Minutes for Task Force on PD Testing of Class 1 Power Transformers

Proposed Changes to IEEE Std. C57.12.00-2015 to support proposed changes for PD Testing of Class I power transformers.

Proposed Changes to IEEE Std. C57.12.90-2015 to support proposed changes for PD Testing of Class I power transformers.

Figure 2 -Induced voltage test for Class II, **and when specified Class I**, power transformers

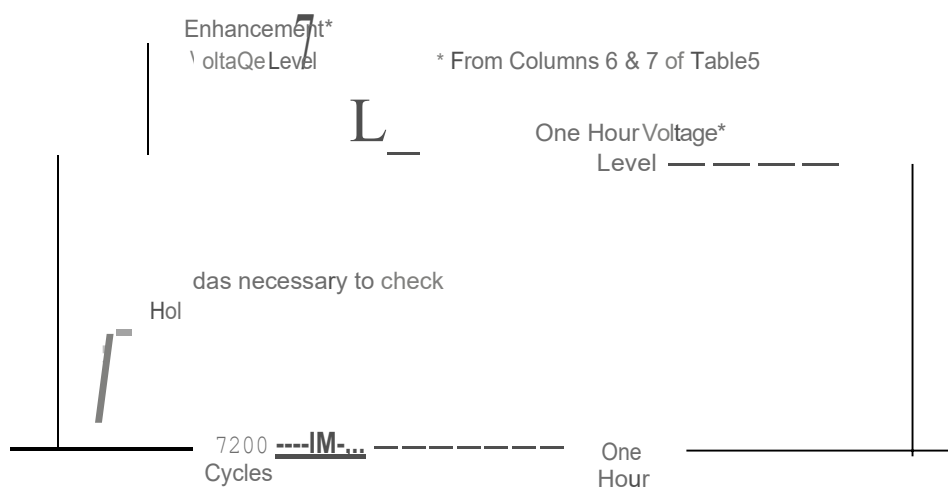
As well for the Voltage/Time graph.

- **5.10.5.5 Induced-voltage test for Class II, and when specified each Class I, power transformers**

With the transformer connected and excited as it will be in service, an induced-voltage test shall be performed as indicated in Figure 2, at voltage levels indicated in Columns 6 and 7 of Table 4. Minimum line-to-ground induced test levels for Class II power transformers shall be a multiple of corresponding line-to-ground nominal system voltage as follows: 1.58 times for one hour tests and 1.8 times for 7200 cycles enhancement level tests.
